Reference: University of California, Davis McClellan Nuclear Radiation Center  
(UCD/MNRC), Docket No. 50-607, Facility Operating License No. R-130

Subject: Requested Amendment No. 4 to Facility Operating License No. R-130. McClellan  
Nuclear Radiation Center

DOCUMENT NUMBER: MNRC-0004-DOC-11

UCD/MNRC ORGANIZATION FOR LICENSING AND OPERATION  
 FIGURE 6.1

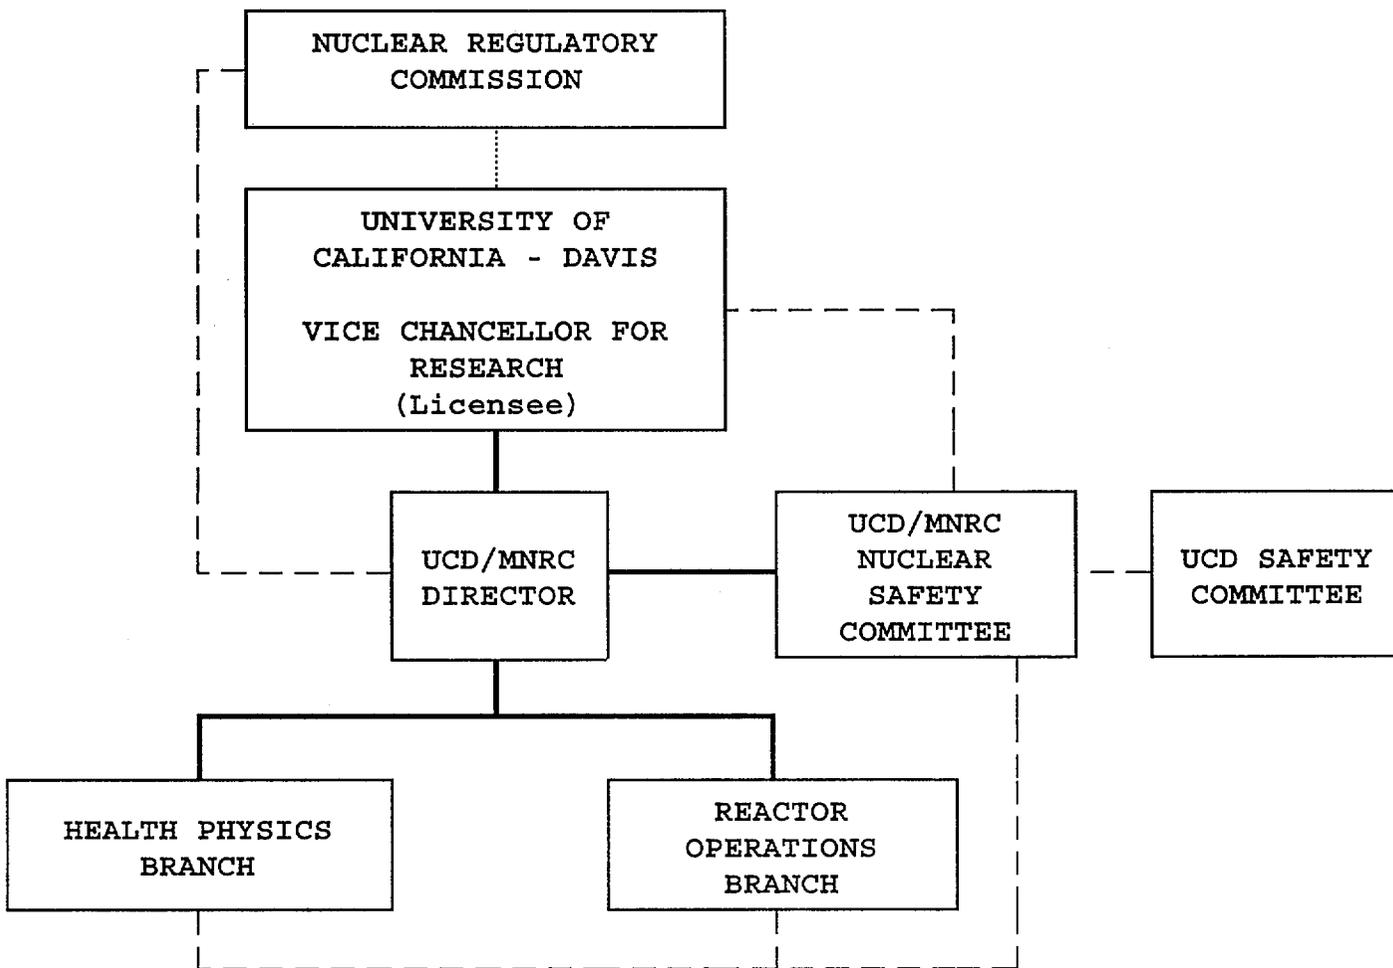
5. Section 6.0: This section has numerous text changes to reflect the new licensee. In addition, there is a new Figure 6.1, Organization for Licensing and Operation, which

incorporates administrative units of the new licensee. Section 6.2 has been changed slightly to reflect the organization and duties of the Nuclear Safety Committee (NSC), and to clarify the Committee's review and audit functions. Subsection 6.6.2 was changed slightly to clarify the NSC's role in the event of a reportable occurrence.
